## **Response to USEPA Region 5 Comments on the Intermediate Design – H.O.D. Landfill**

Comments from the USEPA Region 5 and oversight regarding the H.O.D. Landfill Intermediate Design are presented below followed by the respective responses. References cited in the responses to comments are listed following the last comment/response.

**Attachment 2**  
**Figure 16**

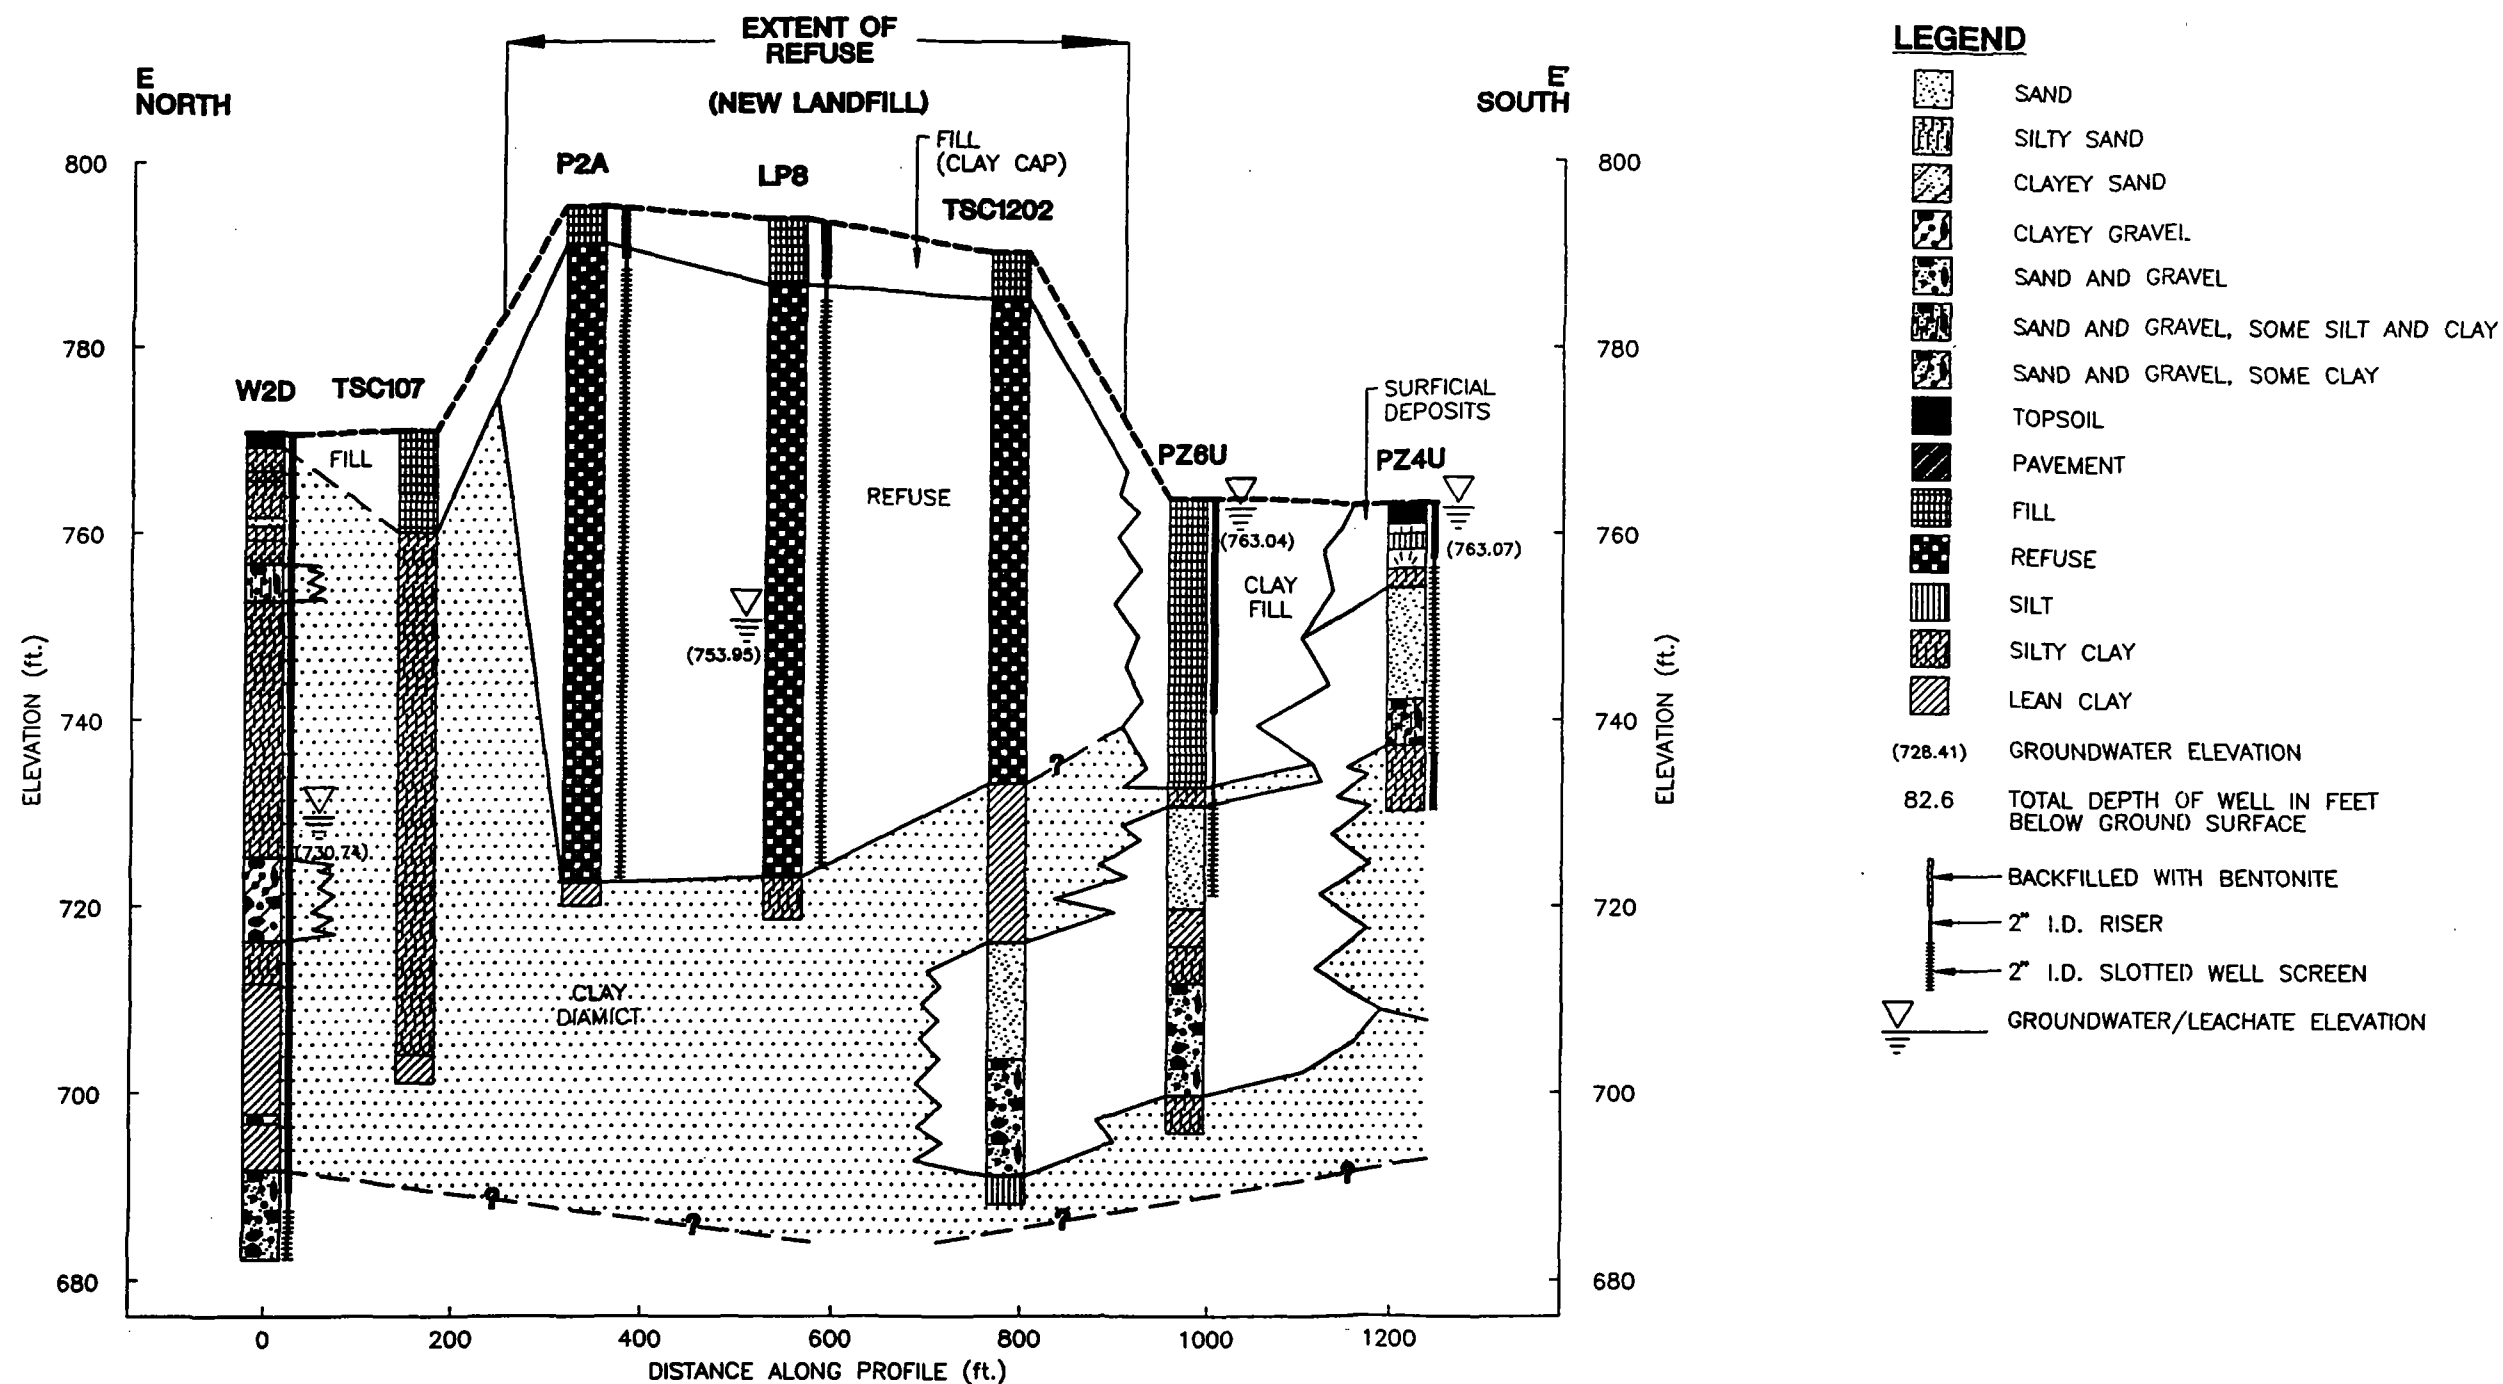
33. **Comment: Page 3-11, Section 3.4.3: In addition to existing and new vertical extraction wells, the selected leachate collection system in the ROD (LC4) included a toe-of-slope collection piping along the north and south perimeter of the "new" landfill only. Justification for not including this collection piping should be provided. It would be expected that if only the interior wells are used to slowly draw down the leachate levels that existing leachate seeps along the side slopes would not be mitigated for period of time. As estimated previously, this time frame should be estimated.**

Response: Drawdown of the leachate levels in the landfill will be accomplished with vertical wells and the existing toe of slope drain pipes (MHE and MHW). Cross Section E-E' (Figure 16 of the RI, see Attachment 2 to these response comments), along with borings along the northern perimeter of the "new" landfill (see Attachment 1), demonstrates that the clay diamicton is laterally continuous to the north of the waste mass. In addition, Cross Section E-E' indicates that the southern perimeter of the "new" landfill is composed of a clay fill "berm" (this is supported by descriptions of the landfill construction process reported in the RI). Along with the steep interior waste slopes along these perimeters, toe drains would not be beneficial or technically constructible.
